# STATE OF OHIO DEPARTMENT OF TRANSPORTATION

## DEF-24-11.35

CONSTRUCT A NEW 0.42 MILE 2-LANE OVERPASS AT THE US24/CR 185 AT-GRADE INTERSECTION & REMOVE CURRENT INTERSECTION. THE PROJECT CONSISTS OF RAISING CR 185 OVER US24 ON THE EXISTING ALIGNMENT, CONSTRUCTING A NEW 2-SPAN BRIDGE & REMOVING INTERSECTION PAVEMENT ON US 24 & RESTORING US 24 TO A 4-LANE DIVIDED FACILITY.

ADDENDUM	NUMBER	DATE	DESCRIPTION
	1	02/14/2025	UPDATED DATE

CULVERT DETAILS  
 STA. 118+21.62

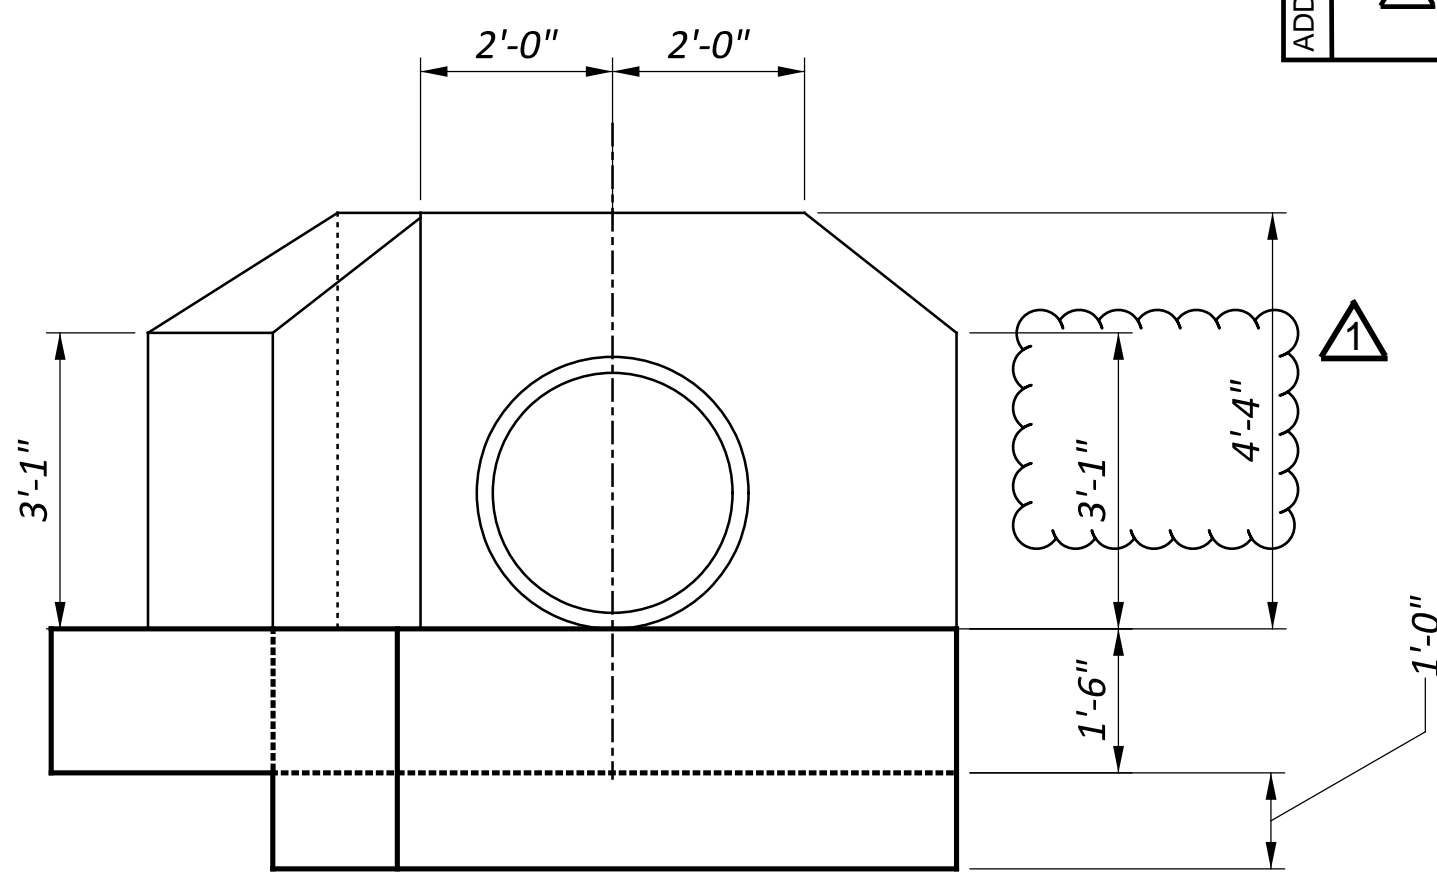
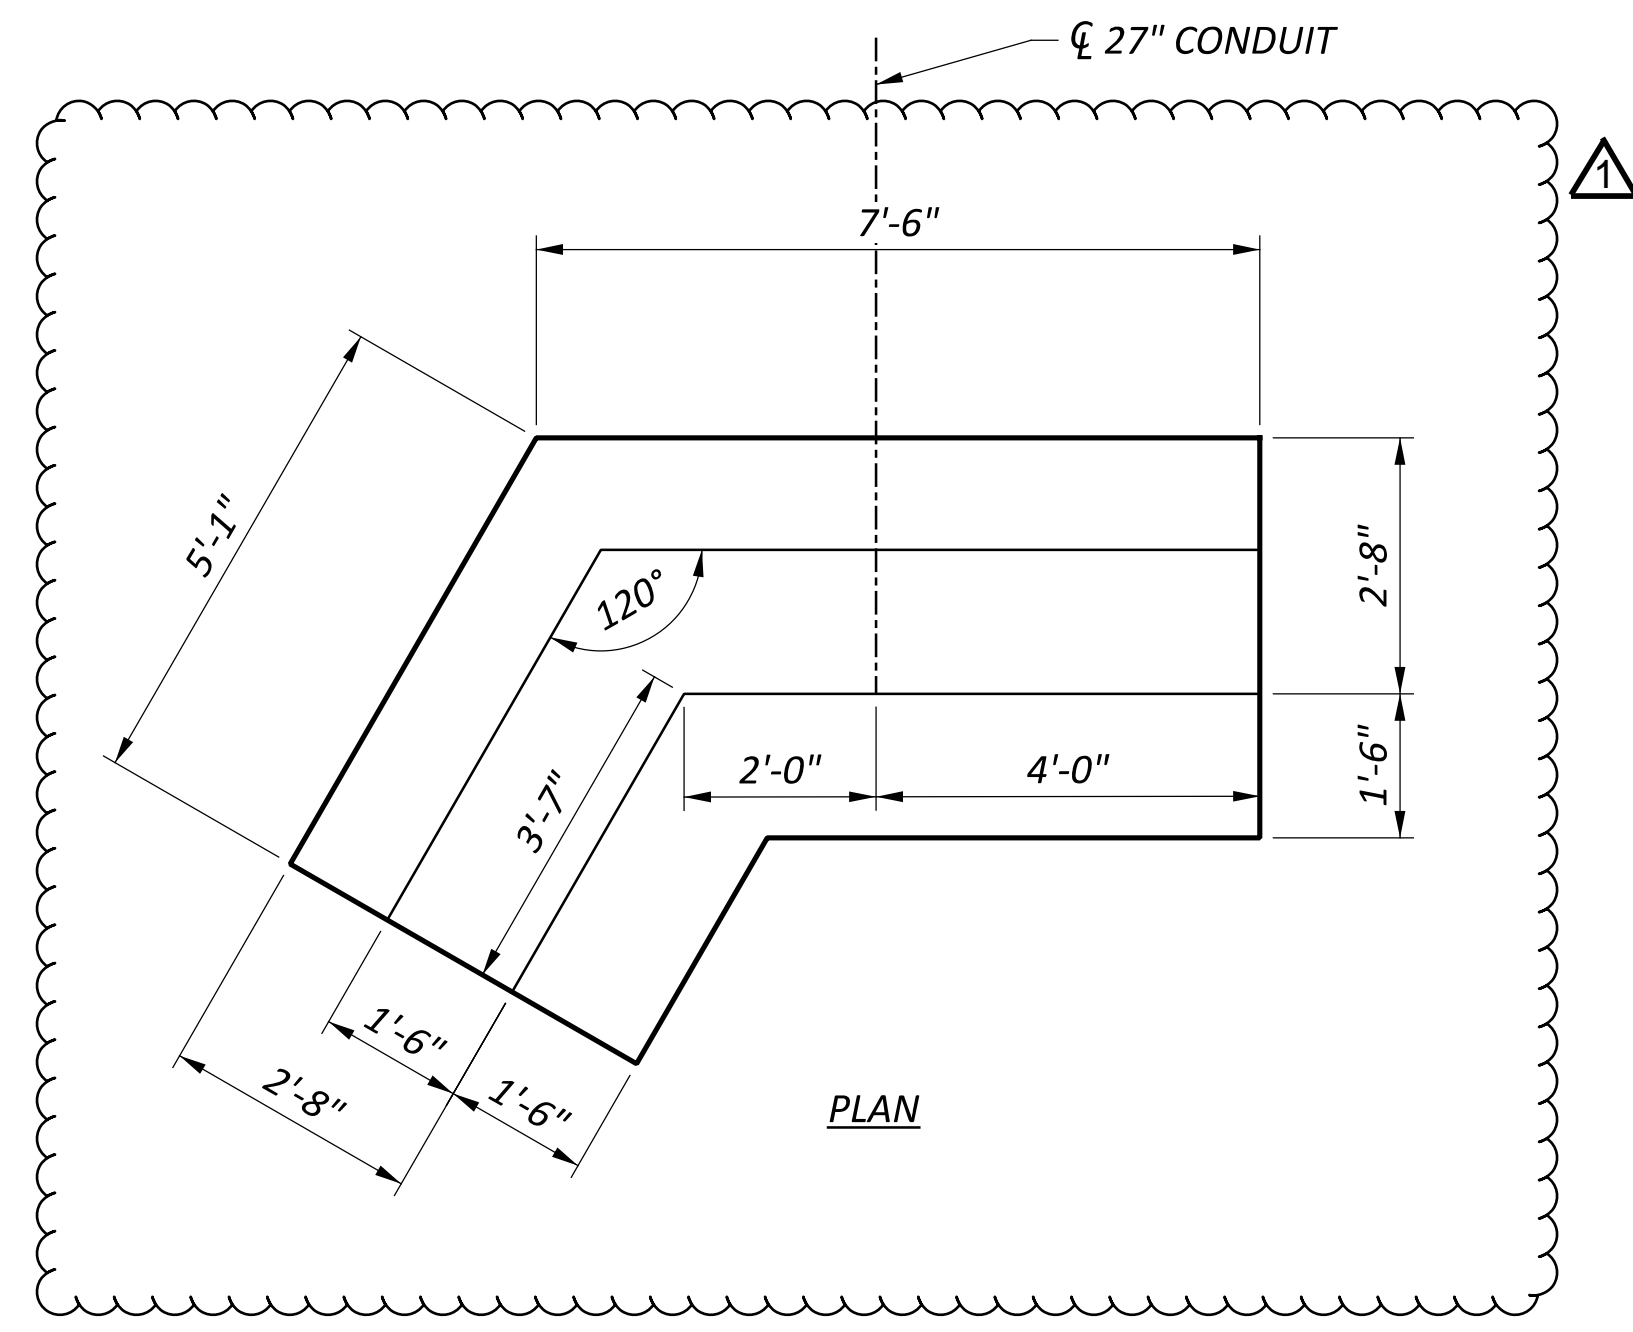
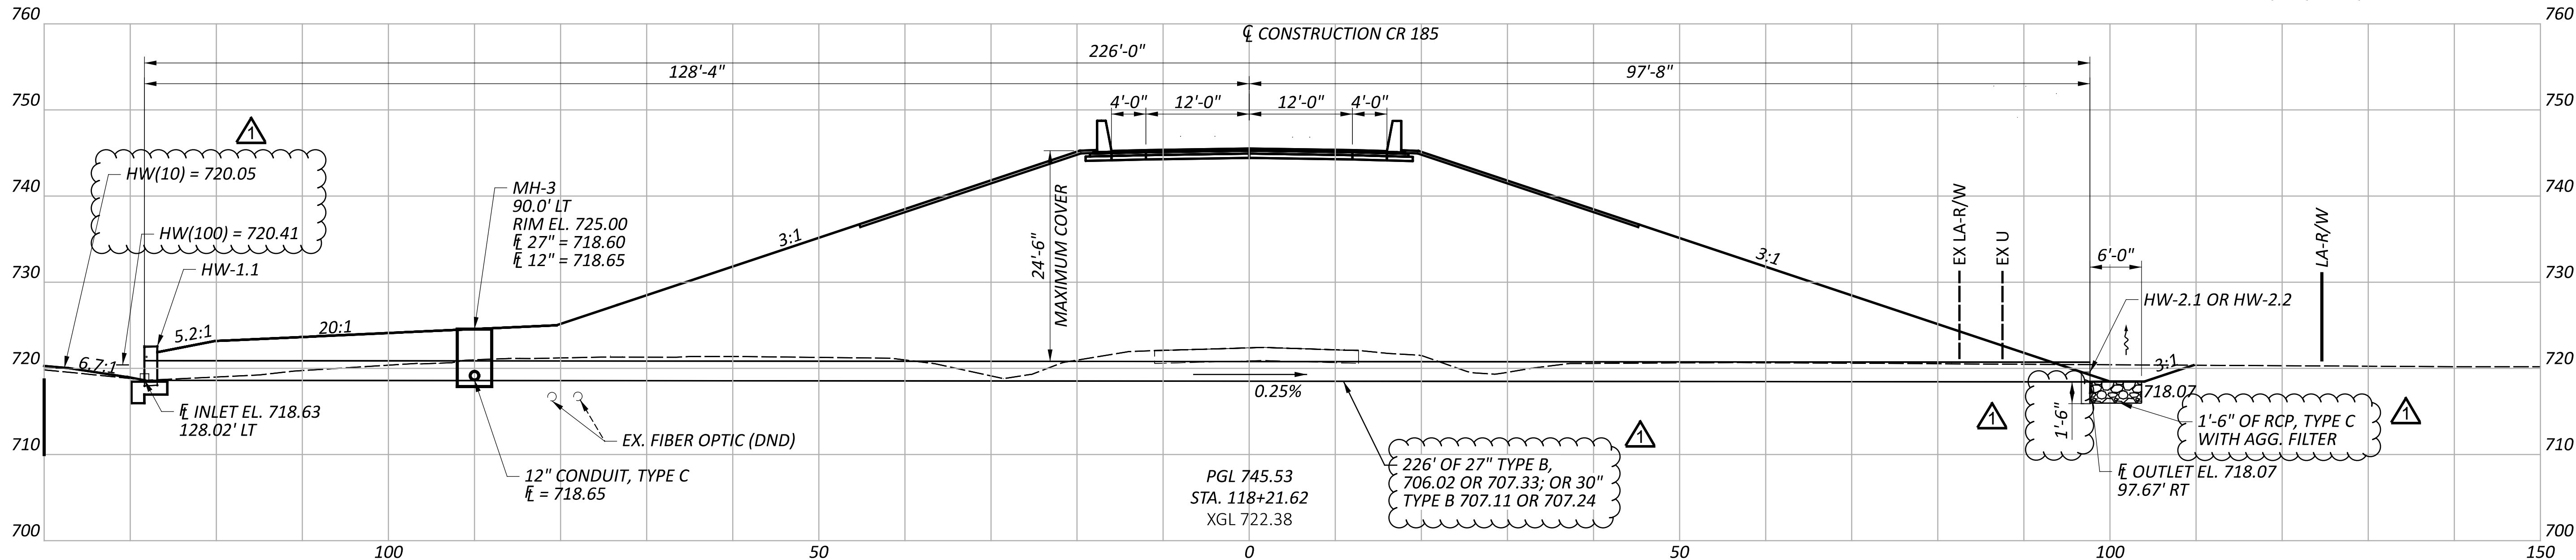
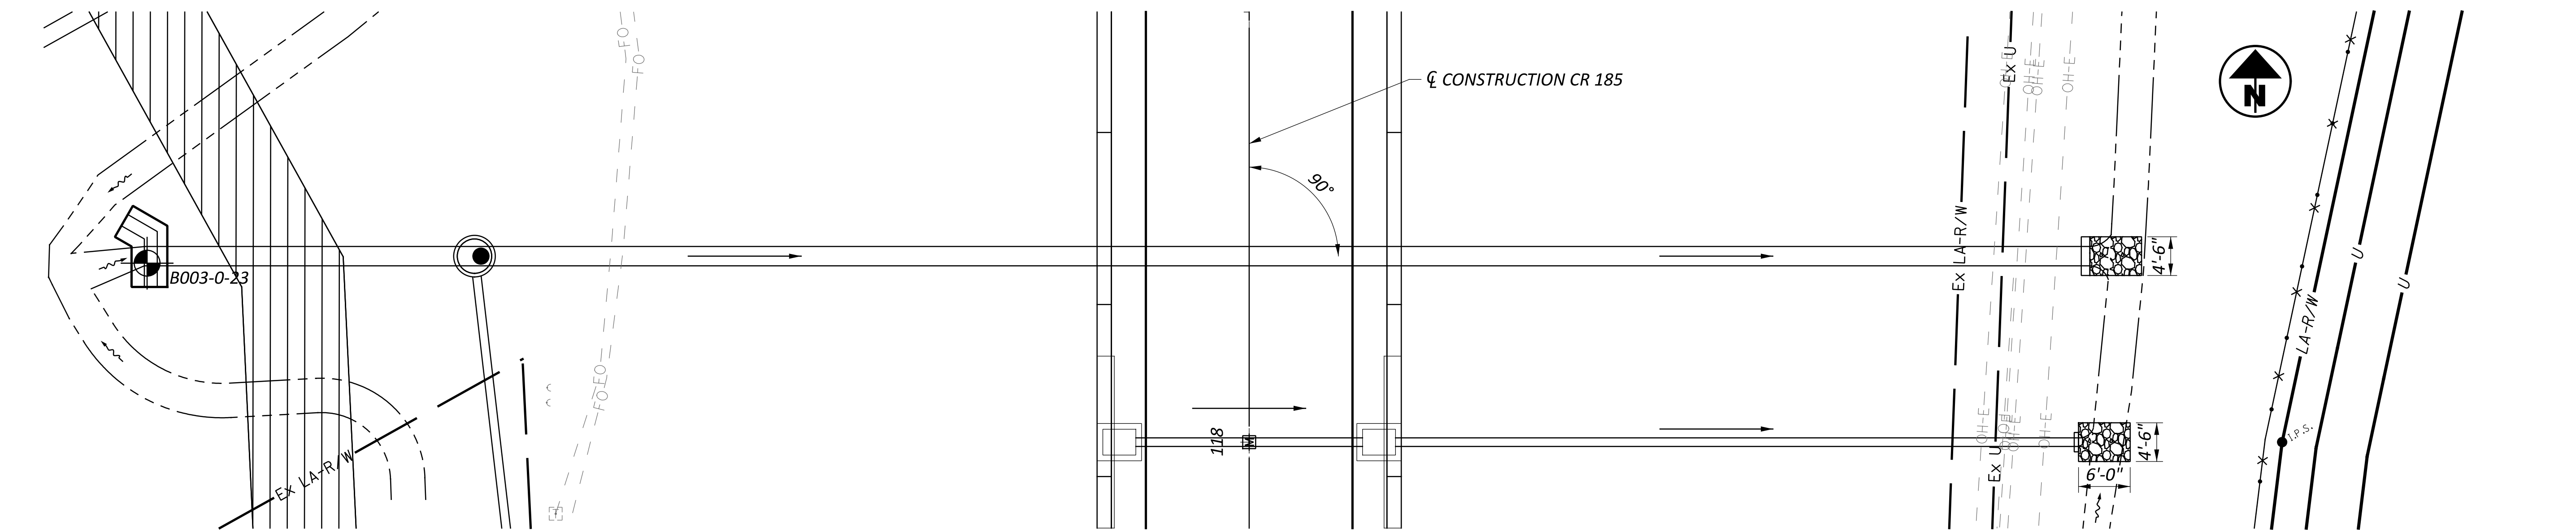
APPENDIX	NUMBER	DATE	DESCRIPTION
▲		02/14/2025	REVISED CULVERT INFORMATION

PROPOSED STRUCTURE	
TYPE:	27" CONDUIT, TYPE B, 706.02 OR 707.33; OR 30" TYPE B, 707.11 OR 707.24
SKEW:	0° L.F.
ALIGNMENT:	TANGENT
CFN:	1996358
